**CERTIFICATE OF APPROPRIATENESS**

**Property:** 2006 Crockett St, lot 5, block 320, Shearn Subdivision. The property includes a historic 1,602 square foot, one-story wood frame single-family residence situated on a 5,000 square foot (50' x 100') interior lot.

**Proposal:** Alteration – Small rear addition, changes to windows/doors and location of openings, and changes to non-original porch elements:

**EAST SIDE ELEVATION**

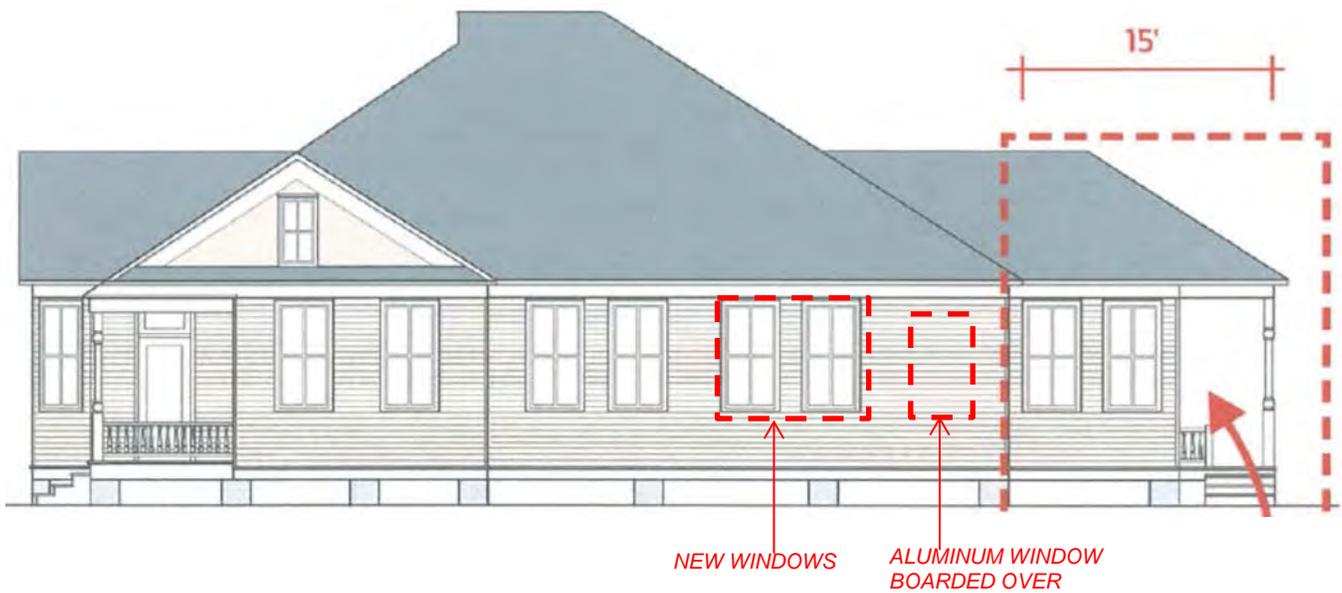
**Side Elevation:** The existing residence contains six wood 2-over-2 windows and an aluminum window. The alteration removes the last two wood windows to be repurposed elsewhere, and replaces them with two new wood 2-over-2 windows in the same openings and boards over the aluminum window opening. The addition extends out 15' and contains two new 2-over-2 wood windows and wood back porch columns.

WEST SIDE ELEVATION

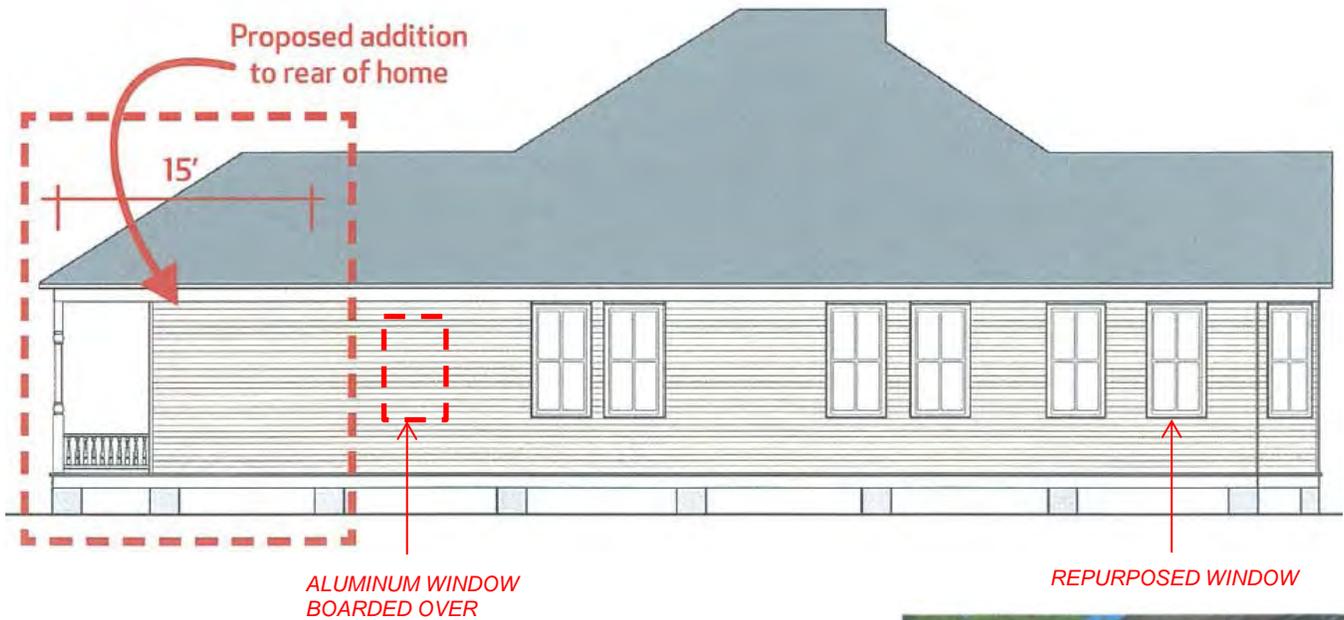
**Side Elevation:** The existing residence contains five wood 2-over-2 windows and two aluminum windows. The addition extends past the rear wall 15' including the rear porch and the aluminum window at the front will be replaced with a repurposed wood 2-over-2 window, and the rear aluminum window will be boarded over.

**DOORS / WINDOWS**

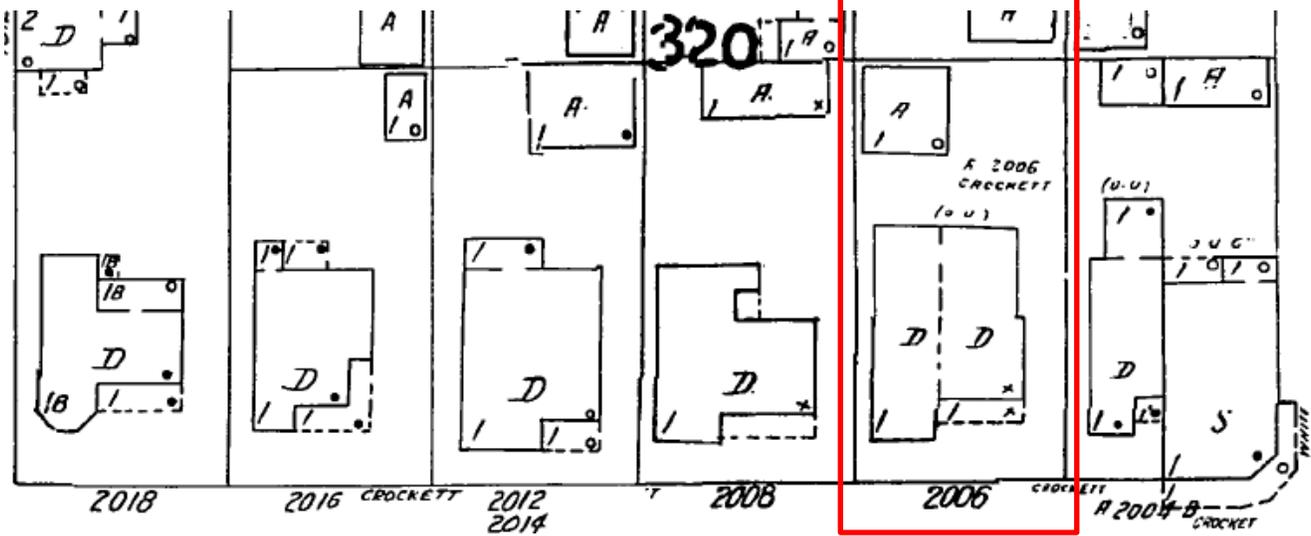
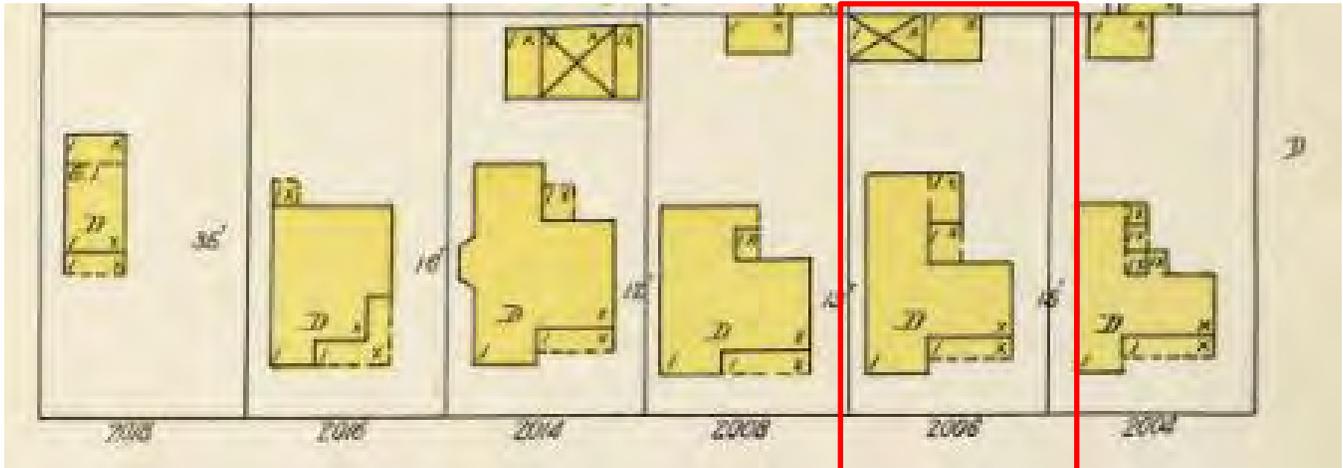
**Denial of the installation of the diamond window.**

**Windows/Doors:** The existing residence has aluminum and wood 2-over-2 windows and two non-original front doors. Two wood windows from the east elevation will be repurposed in place of the door facing the north and an aluminum window on the west elevation. A repurposed wood and glass door will replace the front door facing east and new wood 2-over-2 windows will be used on the east elevation in the same openings and on the new addition.
